The text reproduced below was prepared by the experts from and CLEPA to correct editorial changes to the ECE/TRANS/WP.29/2024/102 submitted to vote at WP.29 194th session. The modifications to ECE/TRANS/WP.29/2024/102 are marked in red and strikethrough for deleted characters.

Annex 2A, correct to read:

Arrangement of the CNG~~LNG~~ Component Type Approval Mark

Example 2

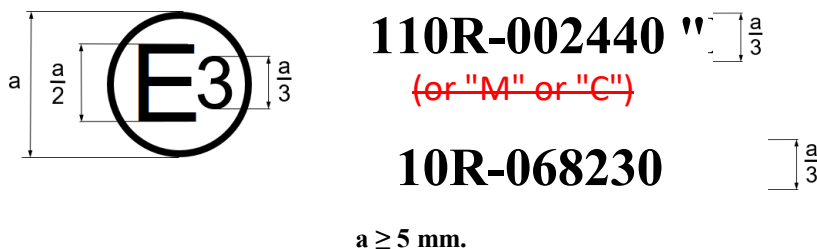
This approval mark when affixed to the CNG ~~and-or-LNG~~ component shows that this component has been approved in Italy (E 3), pursuant to Regulation No. 110 under approval number 002440 and pursuant to UN Regulation No. 10¹ under approval number 068230. The first two digits of the first approval number indicate that the approval was granted in accordance with the requirements of UN Regulation No. 110 in its original form.

The first two digits of the second approval number indicate that the approval was granted in accordance with the requirements of UN Regulation No. 10 as amended by the 06 series of amendments.
